Avon Advisory Planning Commission Meeting  
**Monday, February 23, 2026** at 6:30 pm  
at Avon Town Hall

Planning & Building Department Staff Report

<b>A. PETITION NUMBER</b>	DPR 25-12: 267 Park Place Crossing
<b>B. APPLICANT</b>	Tranquility, LLC, by Kruse Consulting, Inc.
<b>C. LOCATION</b>	56, 82, & 108 Park Place Boulevard (approximate addresses)  Lots 5, 6, & 7 in Avon Park Place
<b>D. PARCEL SIZE</b>	1.68 acres
<b>E. LAND USE &amp; ZONING</b>	The site is undeveloped, is zoned C-2: General Commercial District, and located within Tiers 1 & 2 of the U.S. Highway 36 Zoning Overlay.
<b>F. ACTION REQUESTED</b>	Request for approval of a Development Plan Review to allow for construction of a one-story, multi-tenant commercial building with surface parking and related improvements.
<b>G. HISTORY</b>	<p>The site was platted and recorded in 1988 under the jurisdiction of Hendricks County.</p> <p>This petition was discussed at the September 18, 2025 Technical Advisory Committee (TAC) meeting, and accordingly docketed for the October 27, 2025 Plan Commission (PC) meeting. The petition was continued to the December 22, 2025 meeting, and then to the January 26, 2026 hearing to allow for th

## Exhibit D – Proposed Building Elevations

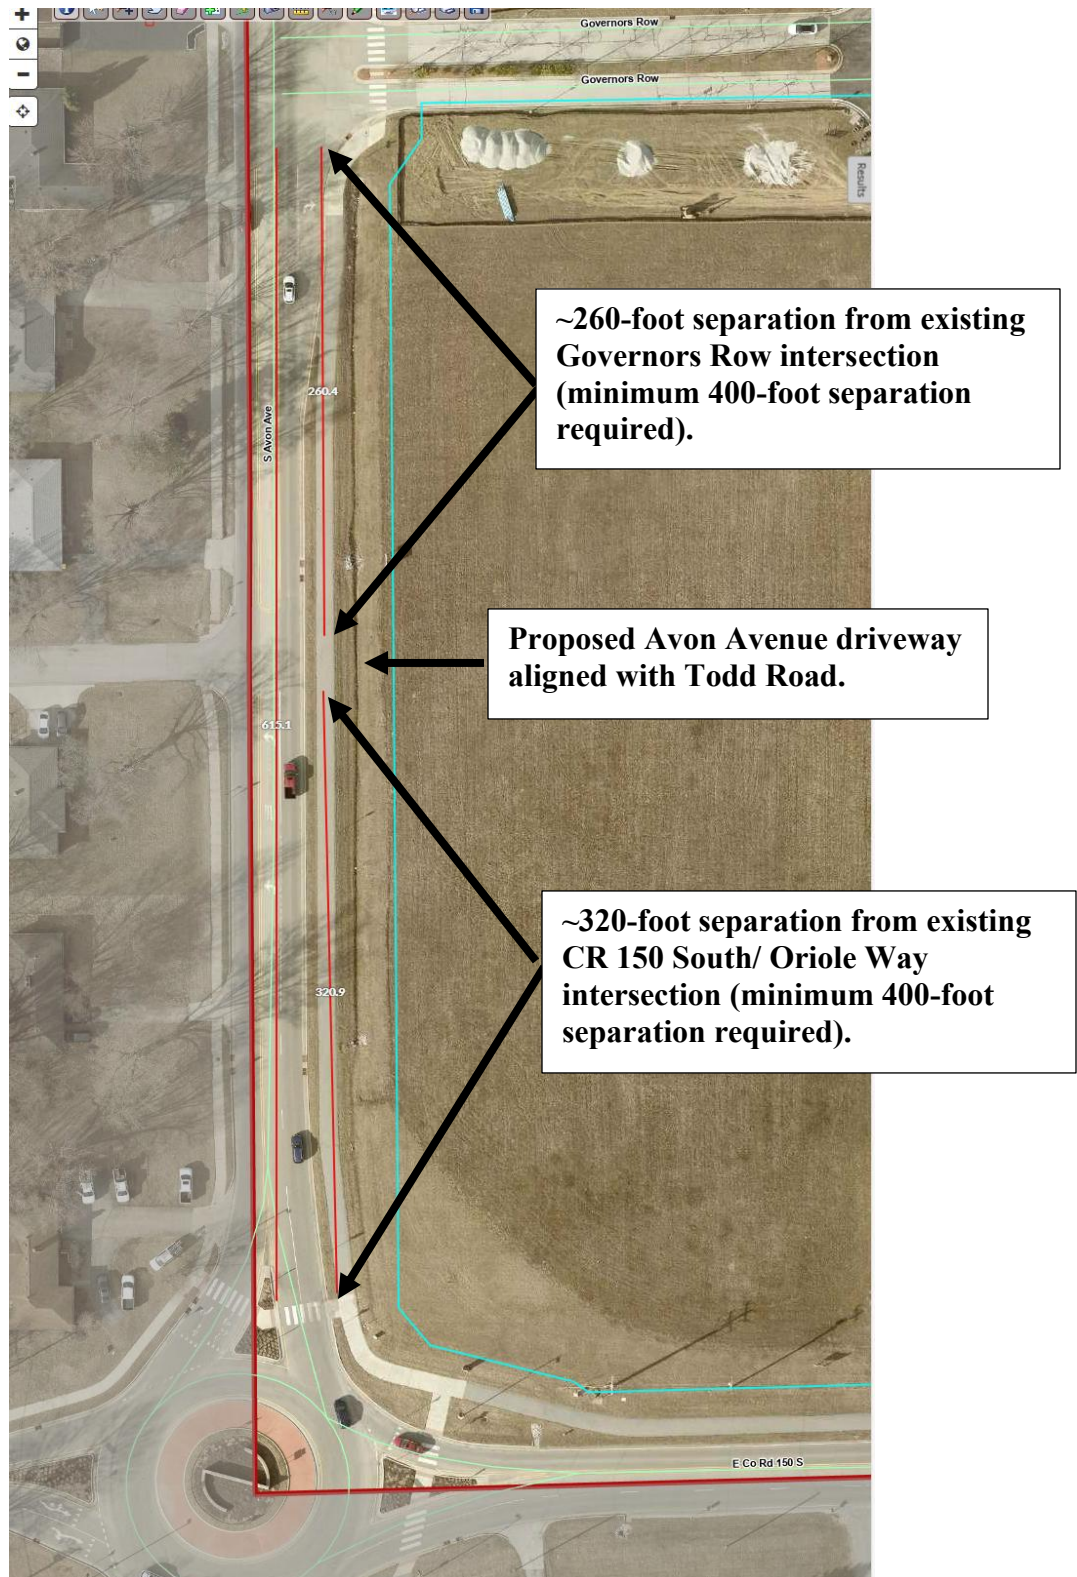
The revised building elevations, submitted subsequent to TAC review, appear to be deficient of several of the architectural standards (see Exhibit D).

UDO 7.10(D)(9) requires that the front of the building provide glazing on a minimum of 35% of the ground floor front façade. The elevations submitted do not provide dimensions and do not provide a calculation of the glazing provided. Staff's evaluation of the front façade has determined that 30% glazing would be provided. The petitioner would either need to provide revised plans or request a waiver.

UDO 7.10(E) requires that two of the five listed roof features be included. The revised plans indicate compliance with only one of these features.

The plans do not indicate compliance with UDO 7.10(H) which requires provision of two of the listed amenity options in order to contribute to the establishment and enhancement of community and public spaces. Plans should be revised accordingly.

# Exhibit F – Lighting Plan

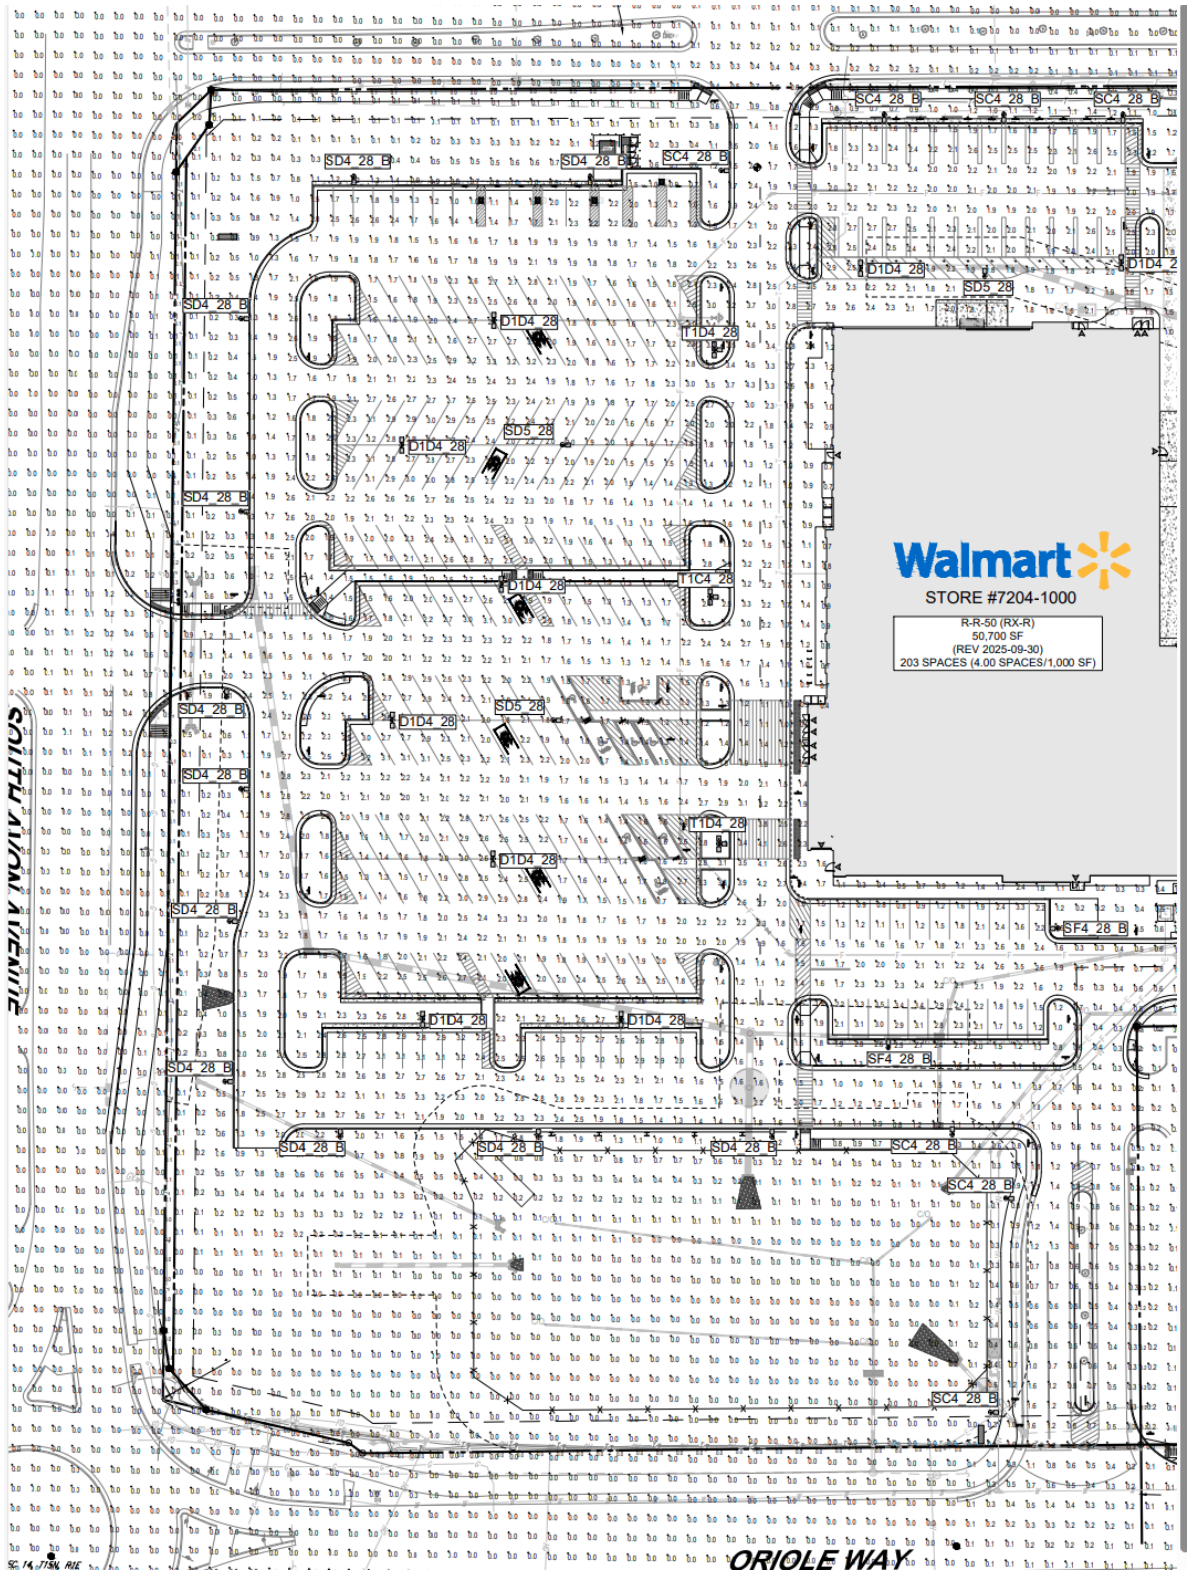
A revised lighting plan indicating an allowable average parking lot lighting level has not been submitted. Therefore, **staff's recommendations for Waivers B & C remain as indicated in the January 26, 2026 staff comments.**
